# SERVICE BULLETIN

JANUARY 21, 1947

SERVICE BULLETIN NO. 4

## REPLACEMENT OF AFT ENGINE LORD MOUNTS

Figure 1

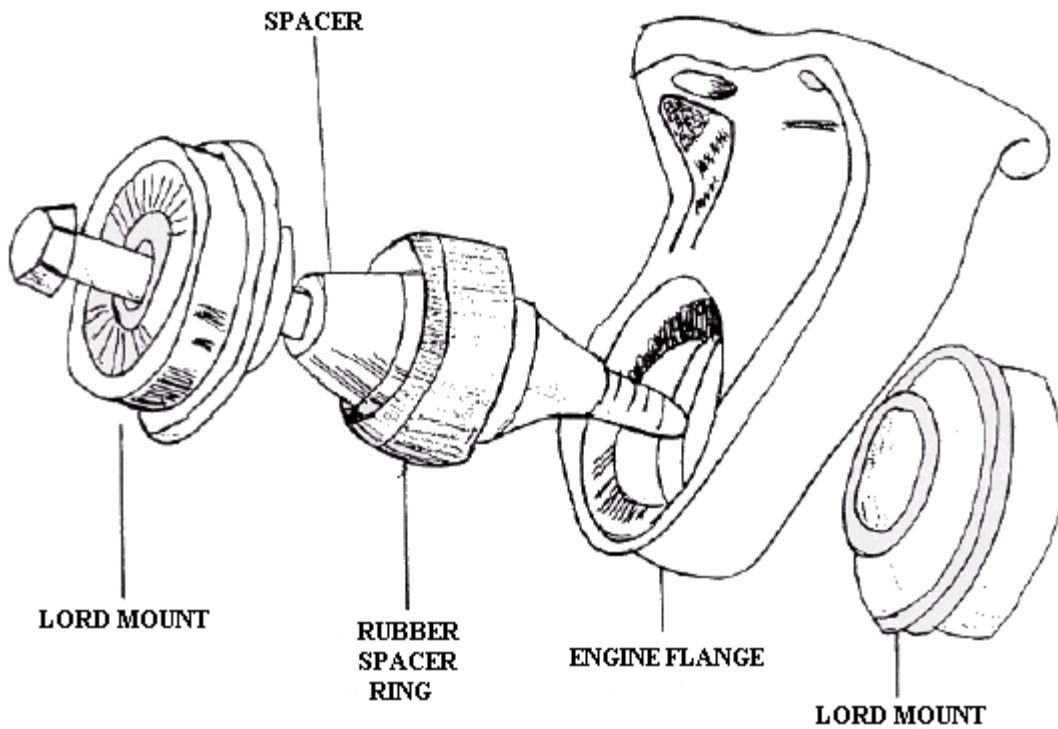
REASON FOR CHANGE: To prevent shearing of rubber bonding on conical halves of the mount  
Resulting from engine static load imposed on them.

This change involves replacement of the present Lord Mount assembly with J-2860-5 Lord Engine Mount Assembly and shall be accomplished as follows:

3. Remove the mount bolt, nuts and washers. Slide the two halves of the mounting brackets aft, and remove the mount assembly which consists of two conical bonded rubber halves and straight metal spacer.

4. Install the new J-2860-5 Mount Assembly consisting of two conical bonded rubber halves, which in appearance are the same as those removed, and the spacer. Before installing the spacer, the rubber spacer ring should be assembled on the spacer by pulling it over the end and sliding it to the center. Install the left hand cone in the engine flange, apex of cone facing inboard, move the left hand mounting bracket flange forward and over this half and start the bolt through the flange and cone. From the right hand side, install the spacer over the bolt and insert the other cone, apex facing inboard. Slide the bolt through the entire assembly. Assemble the washer and nut on the bolt. This bolt should be torqued 38 to 42 foot pounds. This completes the change. Refer to figure 1.
